PUBLIC COMMENT

HAMPSHIRE COUNTRY CLUB PLANNED RESIDENTAIL DEVELOPMENT DECEMBER 2017 DEIS -SUBMITTED VIA EMAIL

ADDITIONAL COMMENTS

Subject: Re: Traffic Commission recommendations to the Planning Board re: the Draft

From the executive version of the DEIS:

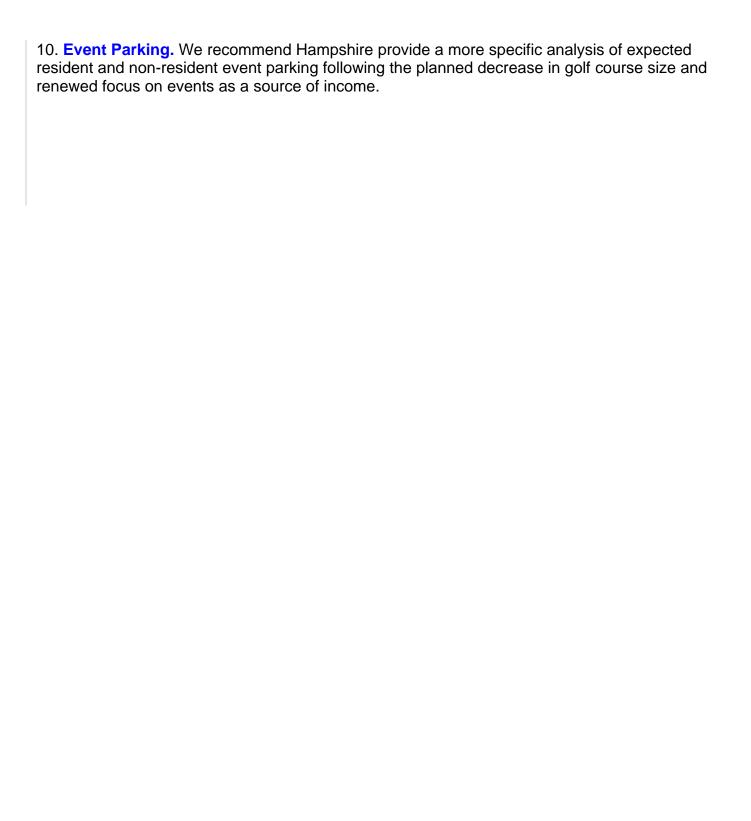
I can only discuss in my personal capacity as the Village Traffic Commission did not officially vote on this, but there is concern that once the Cooper Road access point is built, it will be easy to turn it back into a one or two way road for the development, **as originally envisioned by Hampshire** (relevant excerpt from DEIS executive summary below) and as Old Boston Post Road is **currently used by the rest of Orienta**. Should that happen, there's no guarantee that the developer will then install appropriate sidewalks and other traffic safety measures along Cooper and Old Boston Post Road, as recommended by the Traffic Commission and various other commenting parties.

One thought would be to ask Hampshire to sign a provision that says that if, at any point in the future, Cooper is turned into a one or two way road for use by the development, Hampshire would be required to install a sidewalk from Cooper Avenue to the Old Boston Post Road / Boston Post Road intersection.
